**REVISED
PLANS**

PROPOSED DEVELOPMENT ON
#1 WENTWORTH STREET,
COTTESLOE

From: Dr David Flynn
Sent: Tuesday, 2 October 2018 9:58 PM
To: council
Cc: 1
Subject: 1 Wentworth St Cottesloe Attention : Mr. Ronald Boswell Planning Officer.

OVERSHADOWING
SHOWN SHADED

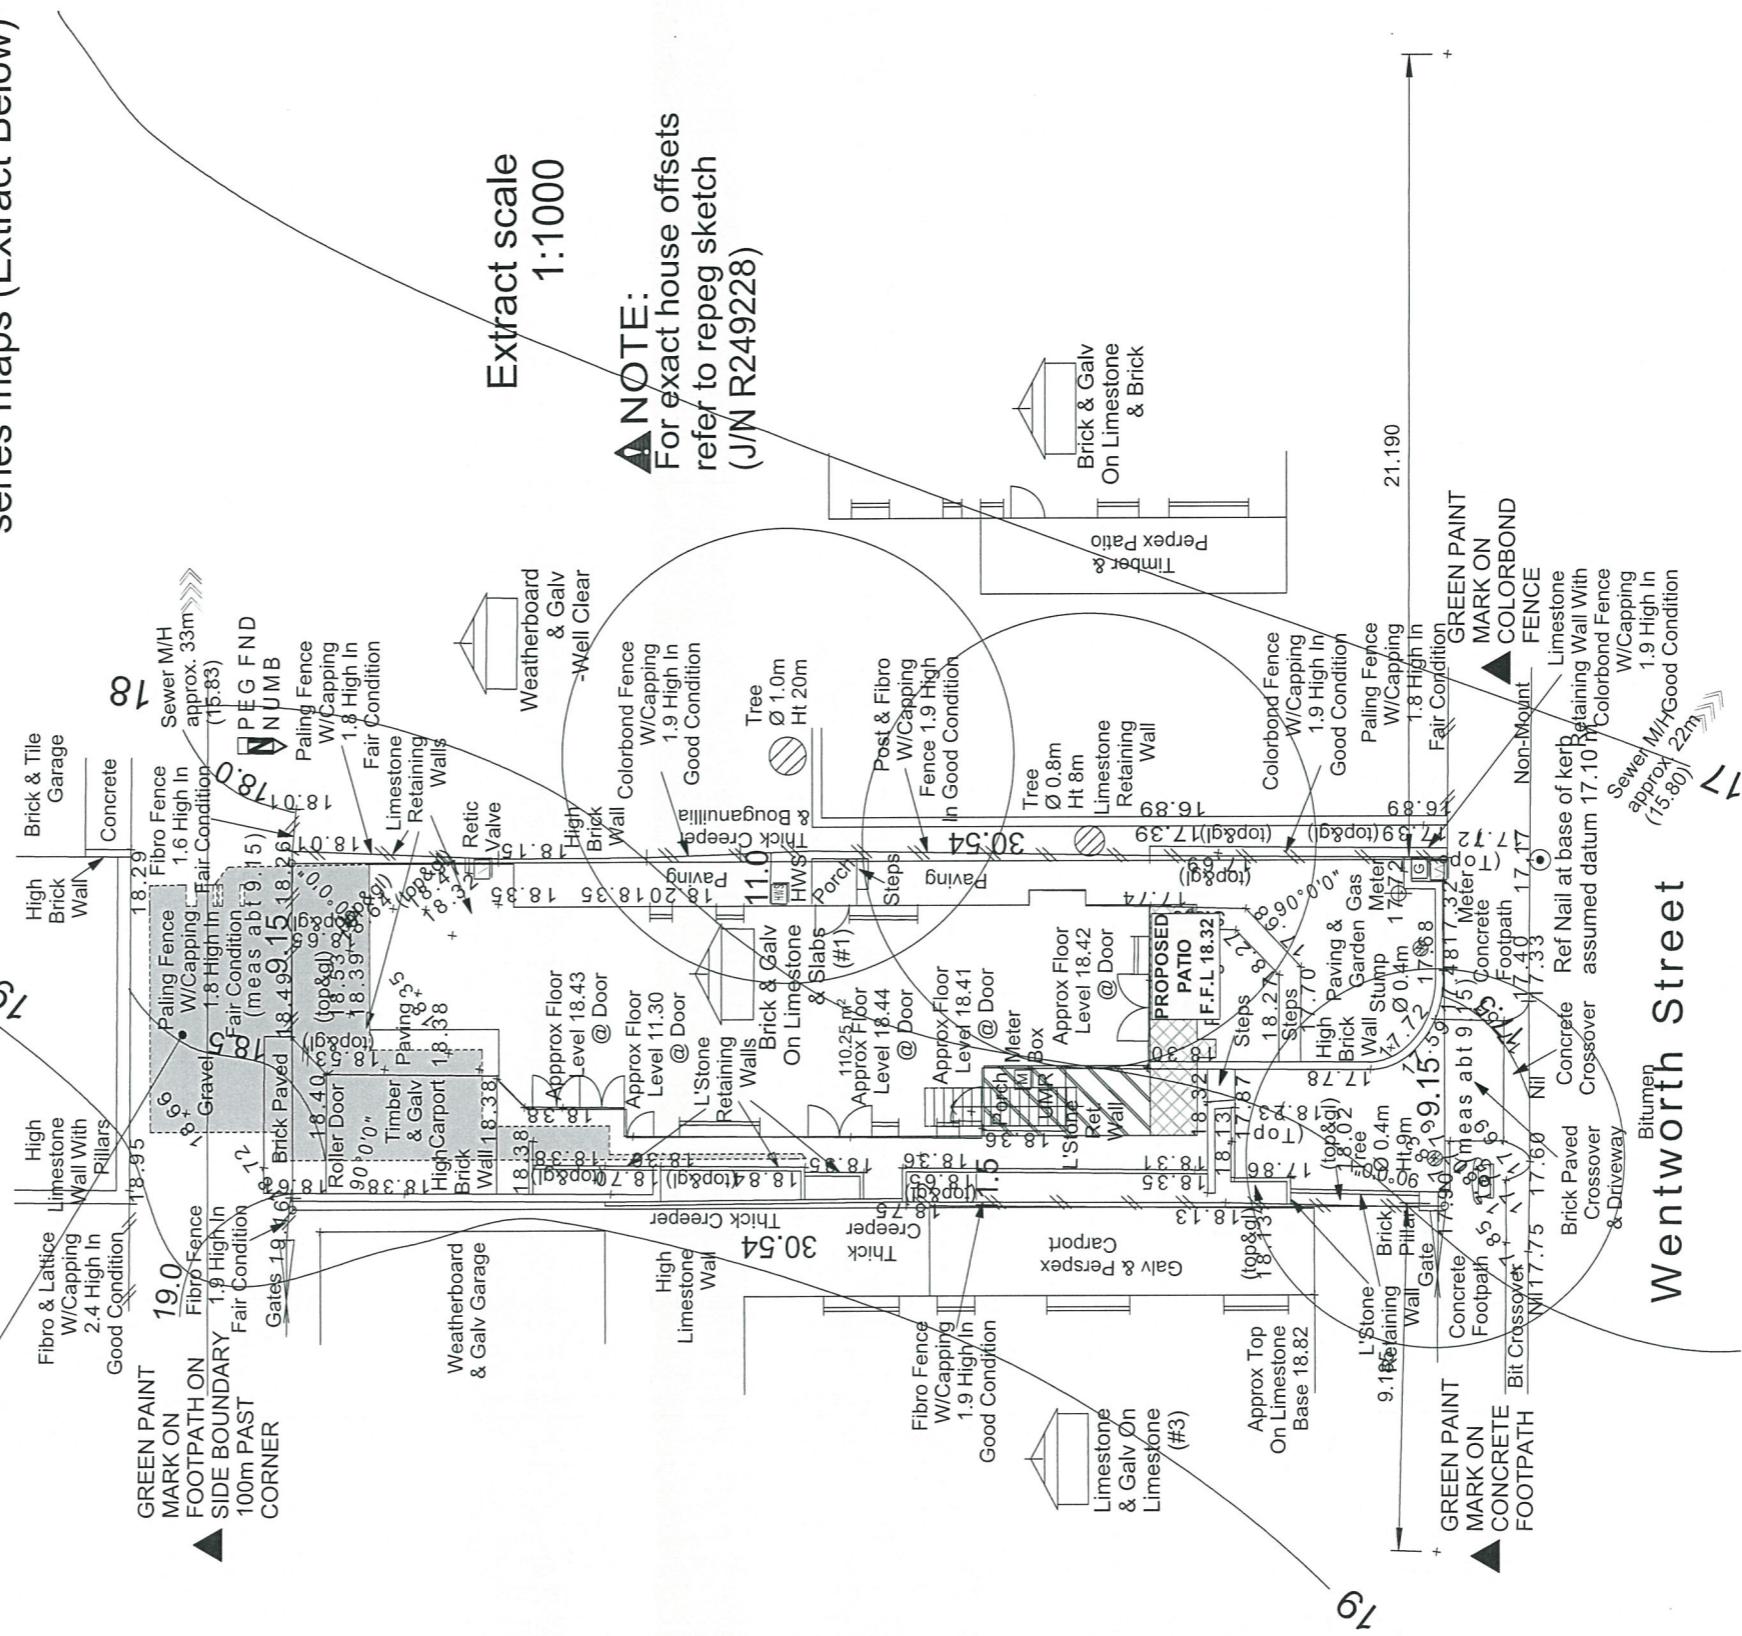
2 : The footprint of the house improvement planned appears closer to the east than the existing structure, so a second story will cause overshadowing on later in the day.
